CONCERNING THE PROPERTY AT 3120 EDGEWATER DRIVE
AUSTIN, TX 78733

Re: 3120 Edgewater Drive, Austin, Texas 78733
Lot 2, Cebar Ranch (Lakeview Acres), Travis County

Thank you for your review comments received July 21 regarding the septic design submittal for the above referenced property. The attached revised design pages are offered in response to the comments indicated in your review. Below is a list of the adjustments contained in the revised design.

Septic System Design for:
The Schulz Residence
3120 Edgewater Drive, Austin, Texas 78733
Lot 2, Cobar Ranch (Lakeview Acres), Travis County

REVISED SHEET 1 - SITE PLAN

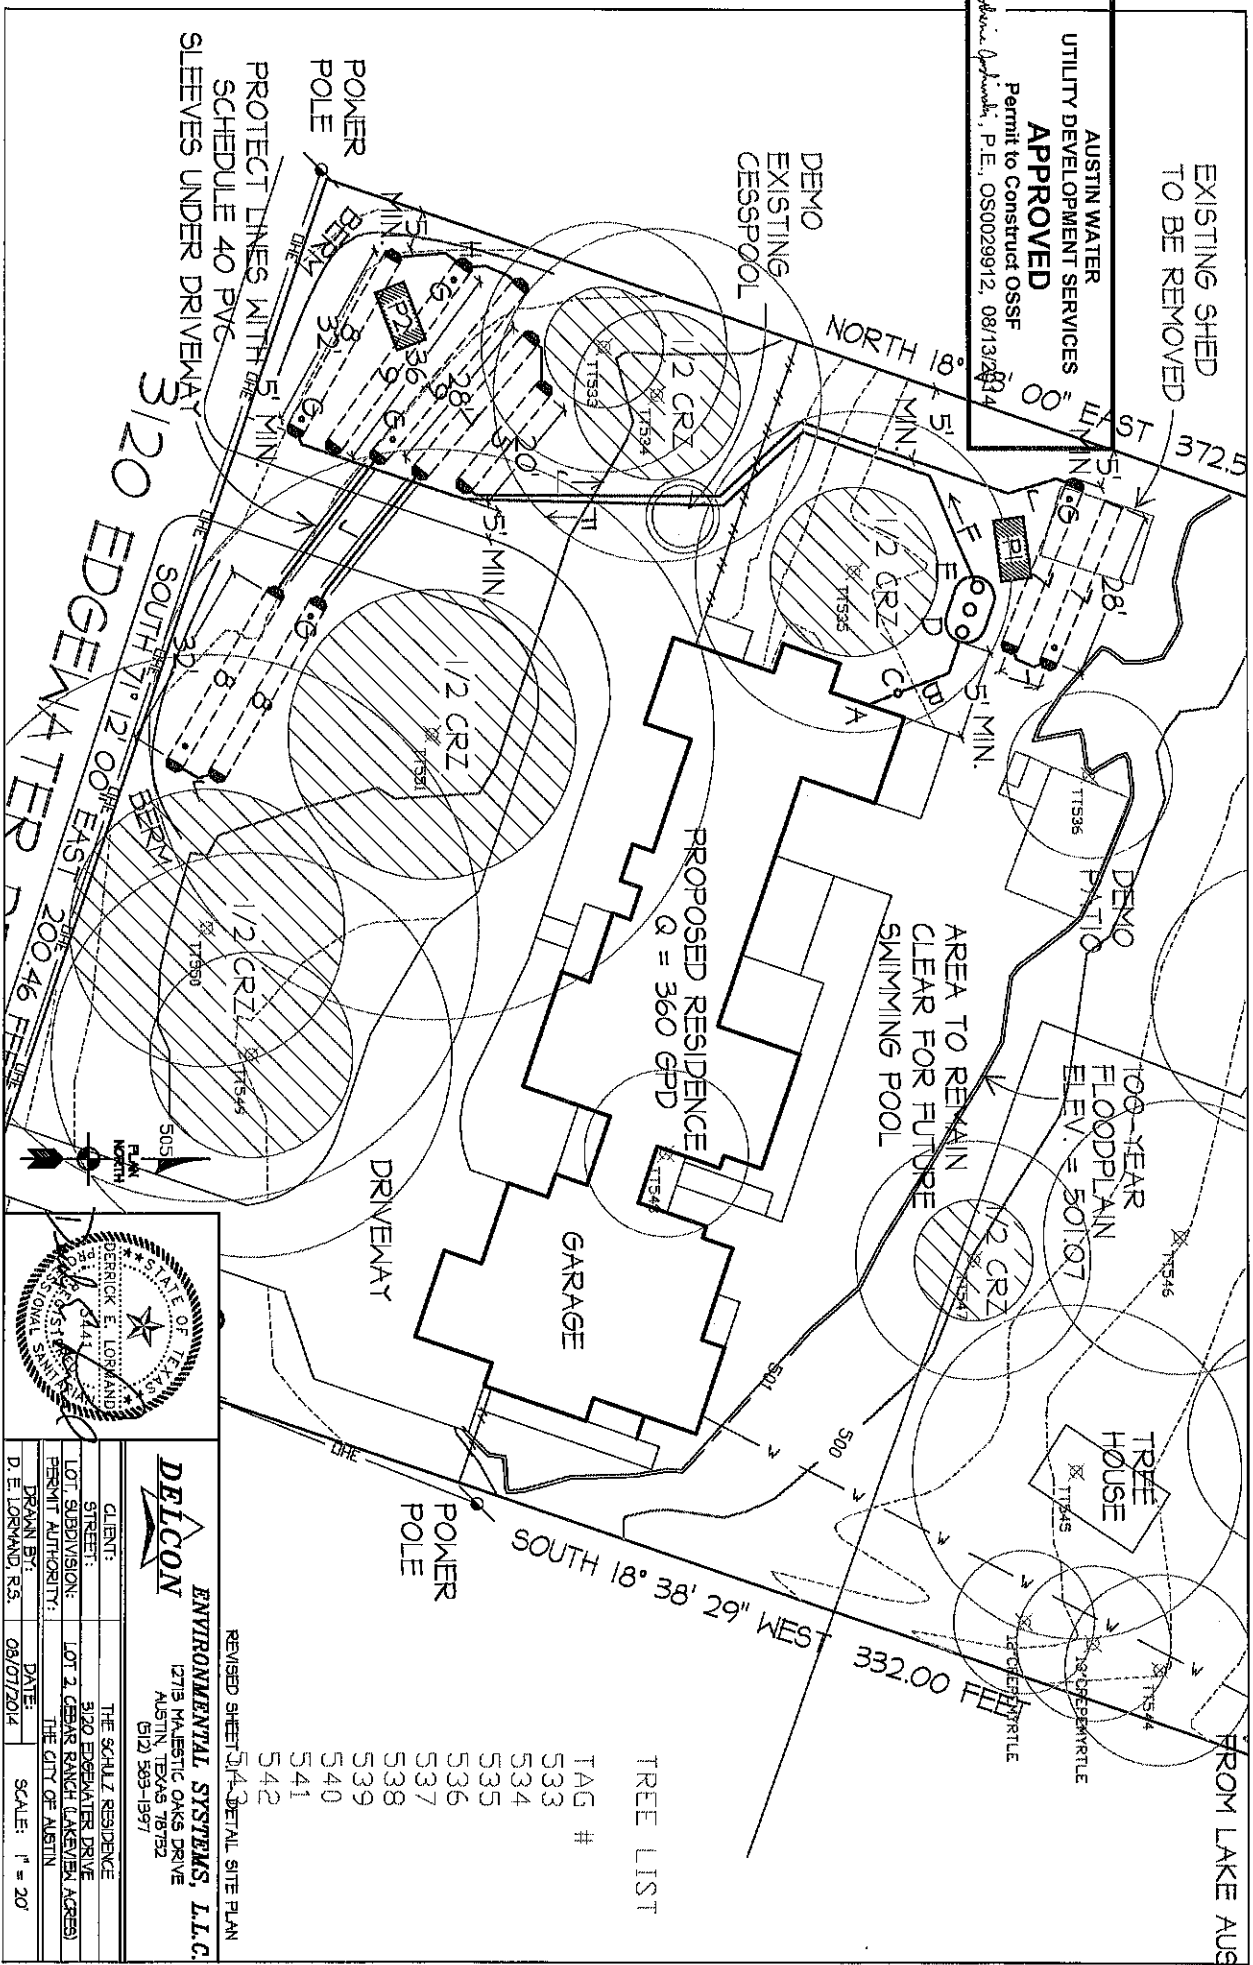
1. Please see the updated site plan with a new propane tank location that is outside the limits of the propose septic system.
2. I am unsure what the Architect is indicating with the rectangles on and around the driveway. Perhaps they are there to represent cars.

6. Please see the adjusted site plan. I have shifted some of the trenches and the routes of the supply manifolds to fit the slope more precisely.
7. The adjusted section detail corresponds to the site plan with a 2" supply line.

REVISION SHEET 2 - SECTION DETAIL

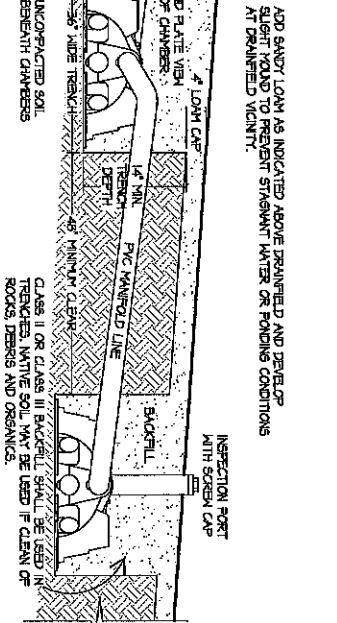
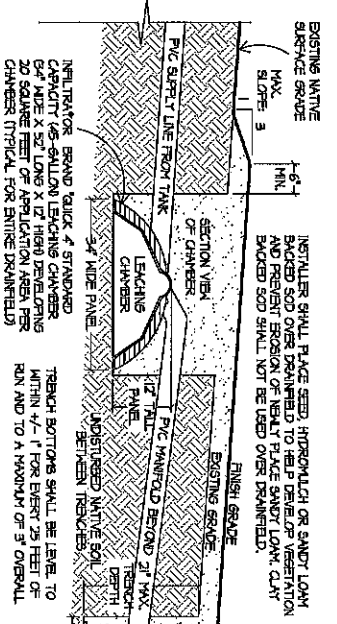
8. I have corrected the maximum trench depth to 21" from 22".
9. Thank you for pointing out the dimension discrepancy in the tank cross-section detail. I have obtained the current specifications from Buchanan Septic Tank Manufacturing and have updated the drawing. The float settings achieve the required reserve capacities.
